Access Compliance Report

Public Rights-of-Way

(Curb Ramps)

Intersection ID: 10034226	Main Street: PEBBLE_RUN_DR	Cross Street: N/A	Location:	N
ADA ID: 16372EDB3D10	Ramp Type: BlendTrans1	Initial Pass/Fail: Pass	Overall Compliance: No	Severity Score: 5
Codes/Mitigation Info/Possible Solution		Field Measurements/Component Compliance

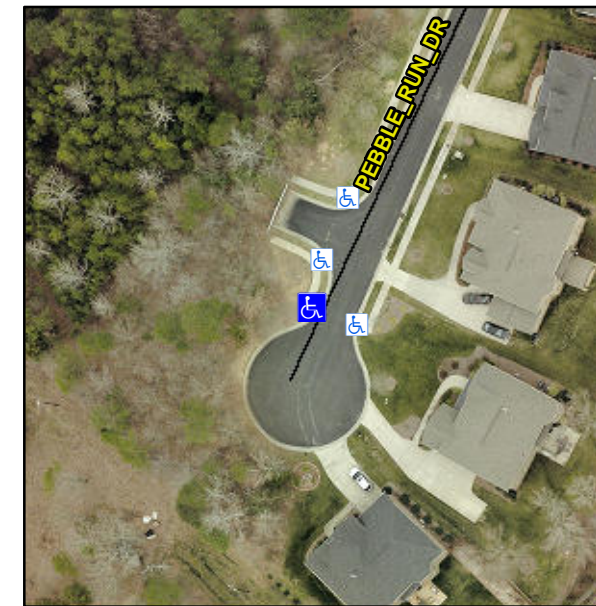
Not Found, R305.2, R304.5.4

Compliance	Description	Data	Compliance	Description	Data
N/A	Ramp Length (in)	49.5	Yes	BlendTrans Slope (%)	3.2
Yes	Ramp Width (in)	48.0	Yes	BlendTrans XSlope (%)	1.4
N/A	Flare Type LT	Sloped	N/A	Flare Type RT	Sloped
N/A	Flare Slope LT (%)	6.1	N/A	Flare Slope RT (%)	3.1
N/A	Flare Traversable LT?	No	N/A	Flare Traversable RT?	No
Yes	Landing Length (in)	48.0	Yes	DWS Provided?	Yes
Yes	Landing Width (in)	48.0	Yes	DWS Contrast?	Yes
Yes	Landing Slope (%)	0.1	Yes	DWS Length (in)	24.0
Yes	Landing X Slope (%)	1.2	Yes	DWS Full Width?	Yes
N/A	Landing Curb? (Y/N)	No	No	DWS Offset (in)	4.0
N/A	Shared Landing?	No			
Yes	Gutter Ponding?	No	No	Gutter Slope (%)	10.7
Yes	Gutter Lip Ht (in)	0.0	Yes	Gutter X Slope (%)	2.4
N/A	Painted X Walk1?	No	N/A	Painted X Walk2?	N/A
	X Walk 1 Direction	To SE		X Walk 2 Direction	N/A
	X Walk 1 Width (in)	N/A		X Walk 2 Width (in)	N/A
	X Walk 1 Slope (%)	2.4		X Walk 2 Slope (%)	N/A
	X Walk 1 X Slope (%)	3.8		X Walk 2 X Slope (%)	N/A

N/A	Ramp inside XWalk1?	N/A	N/A	Ramp inside XWalk2?	N/A
	Road Slope (%)	3.8		Clear Space?	Yes
	Road X Slope (%)	2.4	N/A	Clear Space to XWalk (in)	N/A
Yes	Any Obstructions?	No	Yes	Storm Grate/Utility Hazard?	No
	Obstruction Type			Storm Grate/Utility Type	
		N/A			N/A
			Yes	Surface Condition? (G/P)	Good
			No	Curb Slope (%)	11.3

Remove & Replace Curb Ramp With Two New Directional Ramps or Equivalent. Remove & Replace Gutter.
